Reference: Addendum to Phase II Site Investigation Work Plan, Pacific Dry Dock Yard I,
1441 Embarcadero, Oakland, California; Versar Project No. 2722-012

The purpose of this letter is to serve as an addendum to the Phase II Site Investigation Work Plan for Pacific Dry Dock Yard I, located at 1441 Embarcadero, Oakland, California (the site). The following addendum describes additional soil and groundwater investigation work necessary to produce a preliminary assessment report (PAR) for the site.

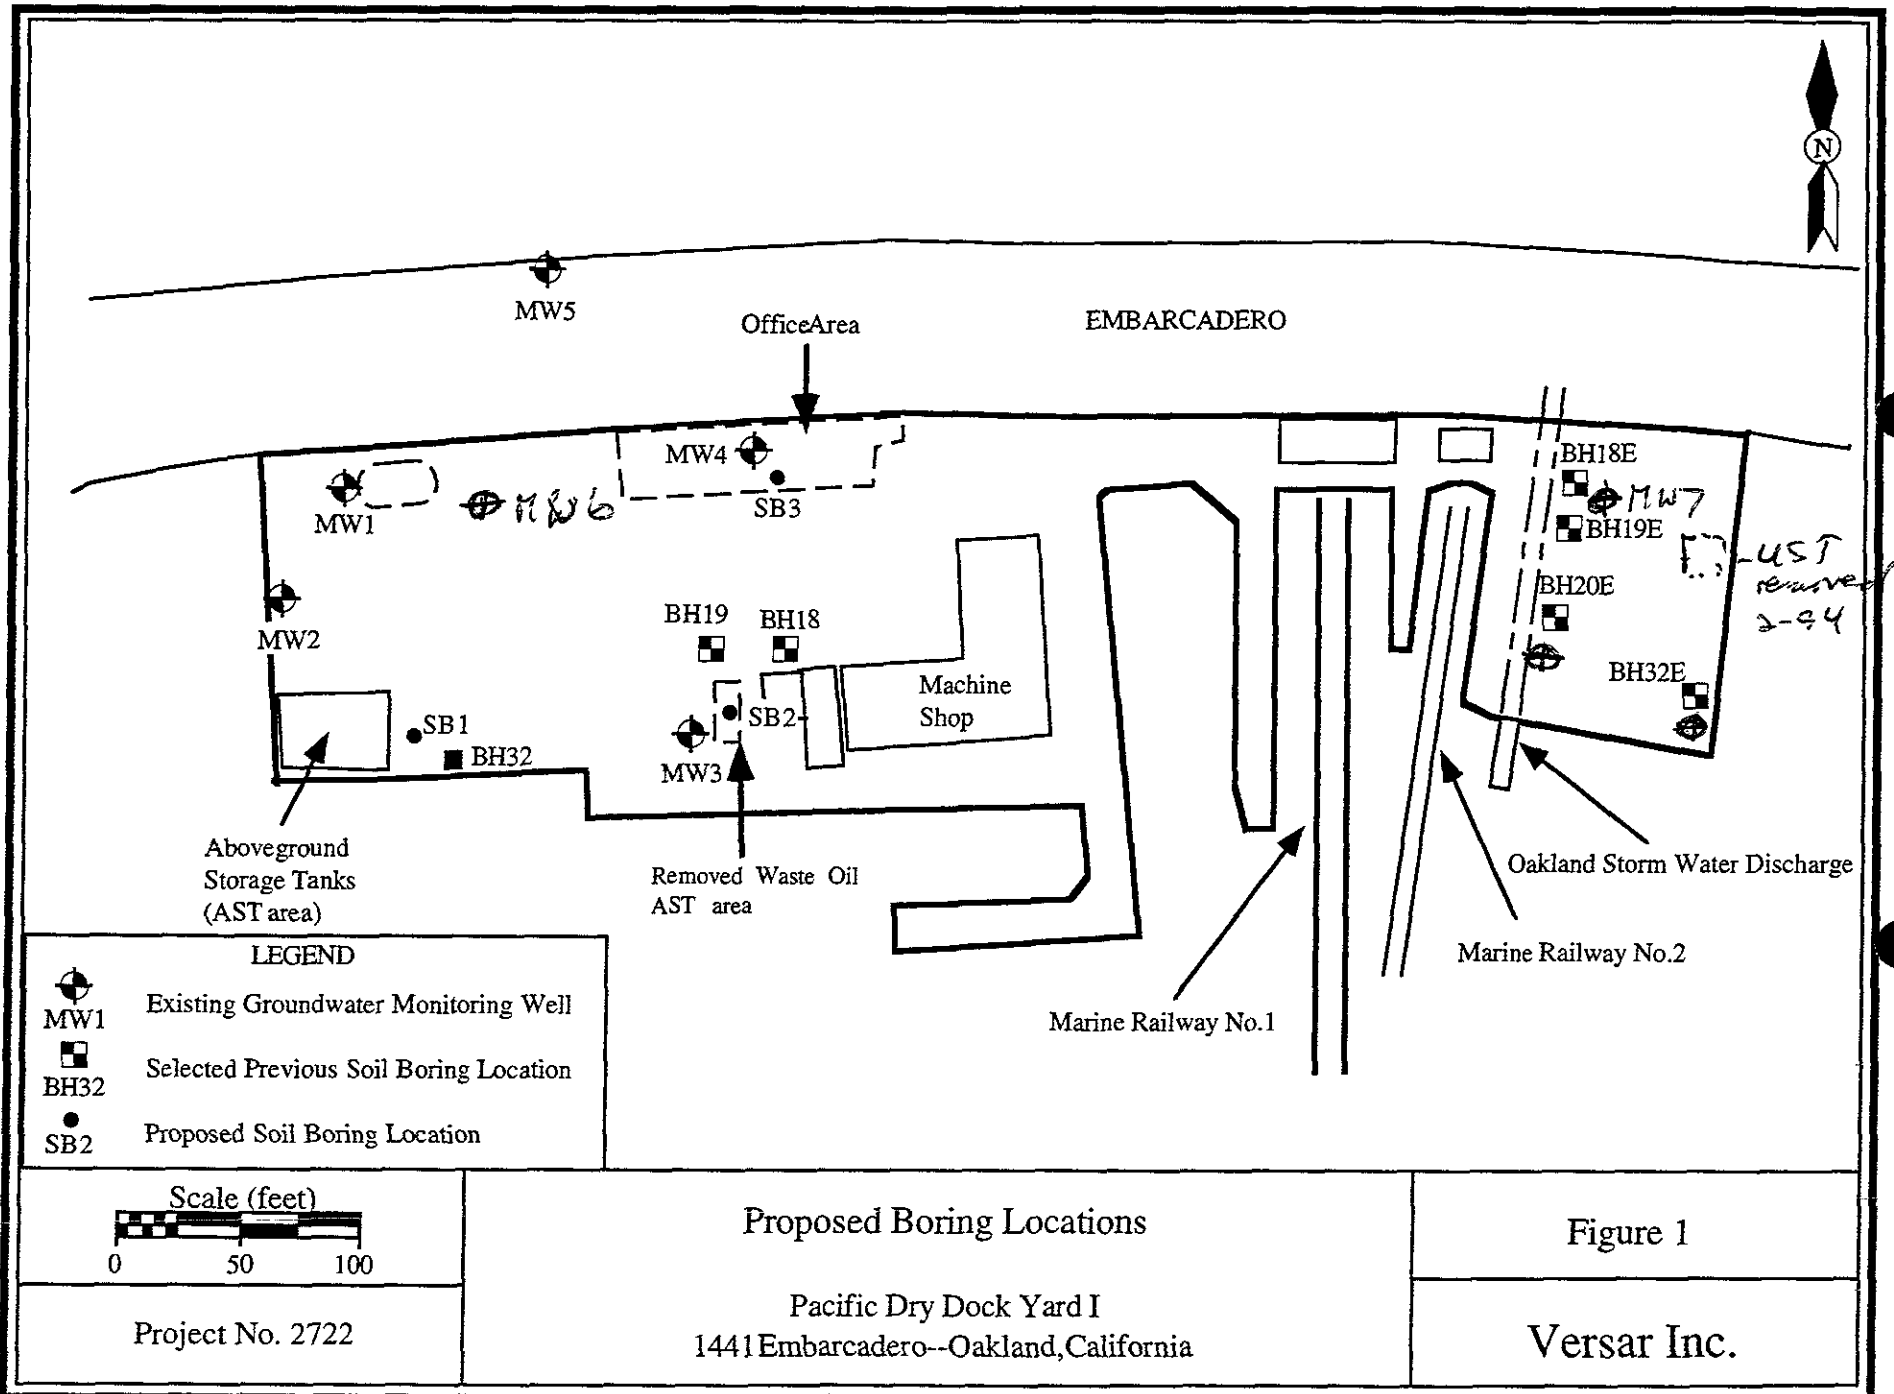
Additional soil sampling will be conducted on a limited basis to provide data necessary to address petroleum hydrocarbon migration at the site. During the investigation, Versar will gather a series of soil samples at the locations shown in Figure 1 using a combination of hand auger, hydraulic coring, and hollow-stem auger techniques. The sampling will be conducted as follows:

- Borehole SB1 will be located near the existing aboveground storage tank (AST) area. One soil sample will be collected from two feet below ground surface (bgs) in the vadose soils where concentrations of total petroleum hydrocarbons as gasoline (TPH-G); total petroleum hydrocarbons as diesel (TPH-D); and benzene, toluene, ethylbenzene, and xylenes (BTEX) were identified previously. A second sample will be collected from the surface of the bay muds at eight feet bgs where the highest concentrations of petroleum hydrocarbons were identified. This sampling will be conducted to determine whether or not these petroleum hydrocarbons have the potential to impact groundwater. Each of these samples will be analyzed for TPH-D, TPH-G, and BTEX, by California Waste Extraction Test (WET).

- Borehole SB2 will be located in the old waste oil AST area. Soil samples will be collected at two feet bgs in the vadose soils and from the capillary fringe located at approximately five feet bgs. TPH-D and BTEX were identified previously at these locations. This sampling will be conducted to determine whether or not these petroleum hydrocarbons have the potential to impact

- Borehole SB3 will be located in the former office area. Soil samples will be collected from five feet bgs in the vadose soils where concentrations of TPH-G, TPH-D, BTEX, and total oil and grease (TOG) (exceeding 1,000 mg/kg) were identified during well drilling, and from the surface of the bay muds at approximately eight feet bgs where high concentrations of petroleum hydrocarbons were identified during previous soil coring. This sampling will be conducted to determine whether or not these petroleum hydrocarbons have the potential to impact groundwater. The samples will be analyzed for TPH-D, TPH-G, BTEX, and TOG by WET.

Figure 2

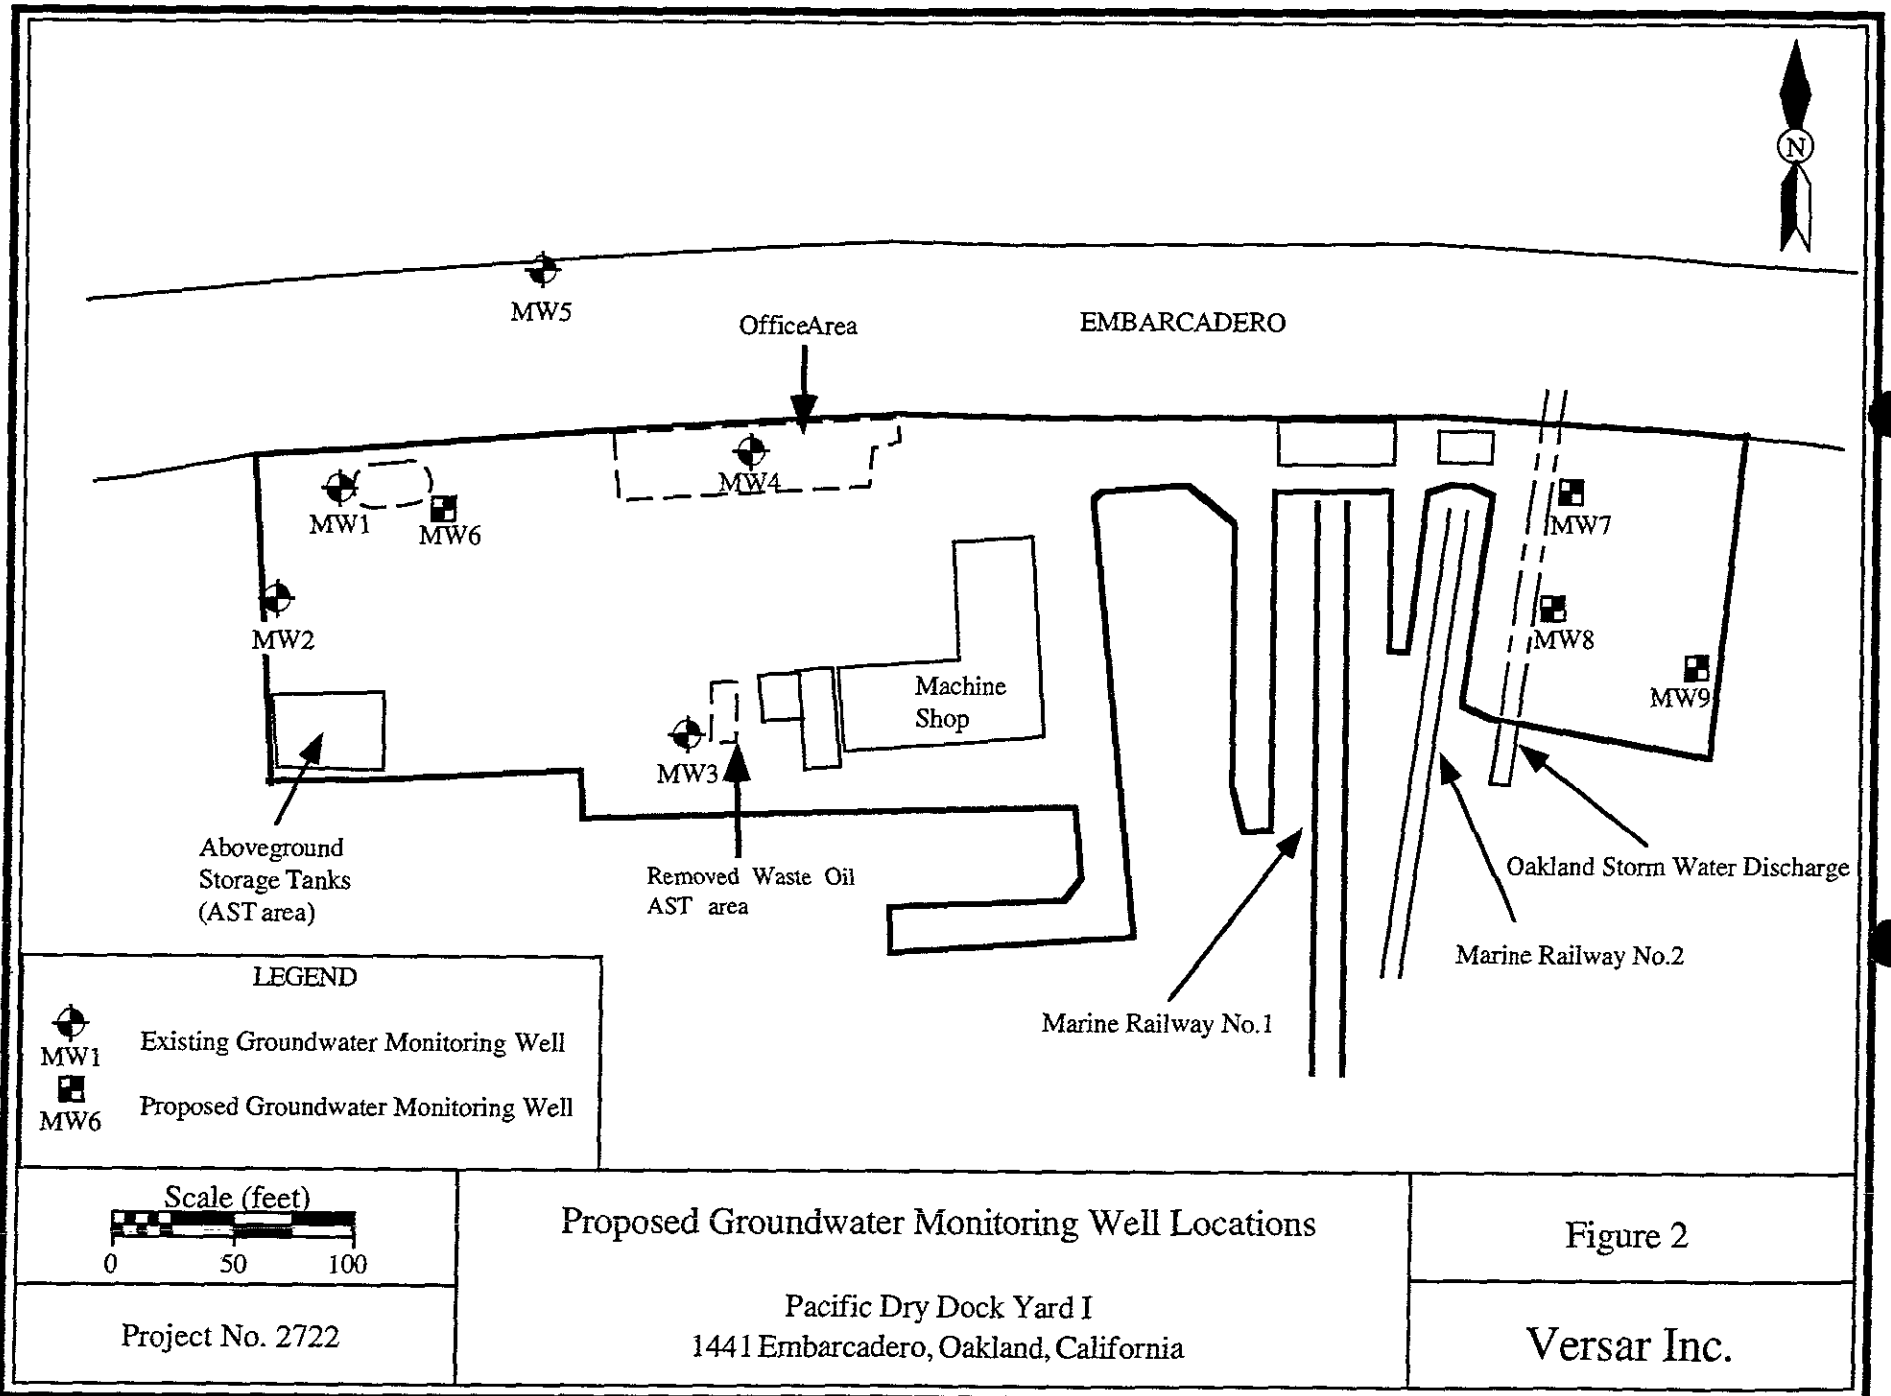
To complete the groundwater characterization, Versar will install four groundwater monitoring wells constructed of 2-inch-diameter PVC with 0.010-inch-slot-size well screen. This will increase the number of groundwater monitoring wells proposed for the site in the Phase II Work Plan from eight to nine. Well boreholes will be advanced using a hollow-stem auger drill rig to a depth of approximately 15 feet bgs. Drill cuttings from the boring process will be placed in 55-gallon steel drums and left onsite until the final site characterization and PAR are complete. The proposed well locations are shown in Figure 2. Figure 3 shows the groundwater monitoring well construction.

The wells will be numbered MW6 through MW9. The well locations and rationale are as follows:

- MW6 will be placed in the verified downgradient direction within 10 feet of the former gasoline UST location on the west side of the site. This placement is necessary to comply with Tri-Regional Board Staff Recommendations for Preliminary Evaluation and Investigation of Underground Tank Sites.
- MW7 will be placed in the northwest corner of the east side of the site, between previous soil coring locations BH18E and BH19E. The purpose of this well is to determine whether the groundwater beneath the site has been effected by the TPH-G, TPH-D, benzene, bis-2-ethylhexyl phthalate, or lead identified in soil samples collected from BH18E and BH19E.

- MW8 will be placed near the southwest edge of the east side of the site, near previous soil coring location BH20E. The purpose of this well is to determine whether TPH-G, TPH-D, BTEX, and bis-2-ethylhexyl phthalate concentrations identified in a previously collected grab-water sample are actually present in the groundwater or whether they were adsorbed to soil particles in the grab sample.
- MW9 will be placed near the southeast corner of the site, near soil coring location BH32E. The purpose of this well is to determine whether the TPH-D, TPH-G, and lead identified in the five-foot-bgs soil sample collected from BH32E have affected the groundwater beneath the site.
